RE: **Lot 15 Block 6 Unser Cliffs Unit 2 SAD 227**
8023 Victoria NW
Grading and Drainage Plan
Engineers Stamp Date 10/18/17 (E10D040)
Pad Certification Date 10/23/17

DRAINAGE AND TRANSPORTATION INFORMATION SHEET (REV 09/2015)

ENGINEER'S SEAL  10/18/17 10/16/17	8023 VICTORIA DRIVE, N.W.	DRAWN BY WCMJ
	GRADING AND DRAINAGE PLAN  <i>Rio Grande Engineering</i> 1606 CENTRAL AVENUE SE SUITE 201 ALBUQUERQUE, NM 87106 (505) 872-0999	DATE 10-15-17
DAVID SOULE P.E. #14522		21810-LAYOUT-10-16-17
		SHEET # —
		JOB # 21810

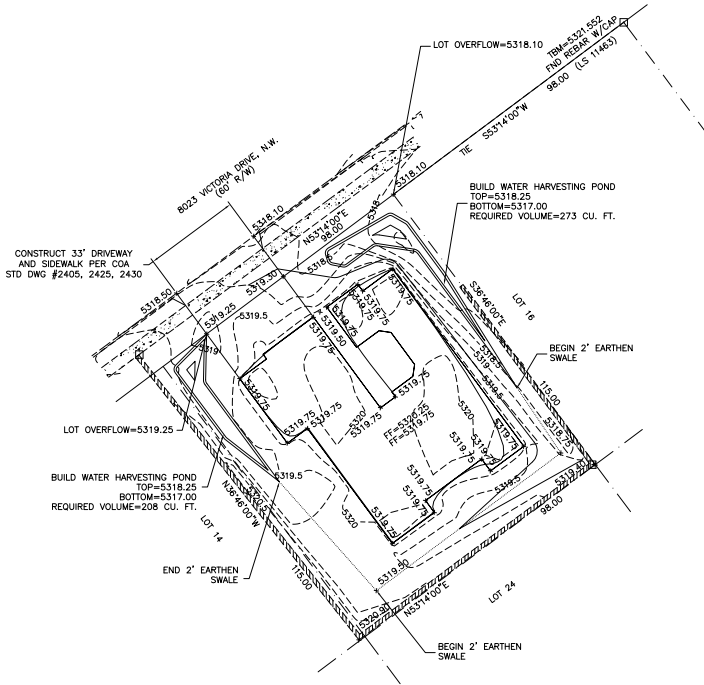
- Provide a statement on the plan stating that this grading plan must be submitted for the application of any garden/retaining walls.

1. ALL SPOT ELEVATIONS REPRESENT FLOWLINE ELEVATION UNLESS OTHERWISE NOTED.
2. ALL SLOPES SHALL BE 3:1 MAX. AND GRAVEL OR NATIVE SEEDING PRIOR TO CO.
3. A PAD CERTIFICATION IS REQUIRED PRIOR TO RELEASE OF BUILDING PERMIT.
4. ANY ONSITE PERIMETER WALLS MUST CONFORM TO THIS PLAN. A COPY OF THIS PLAN MUST BE SUBMITTED WITH WALL PERMIT APPLICATION

ADDED
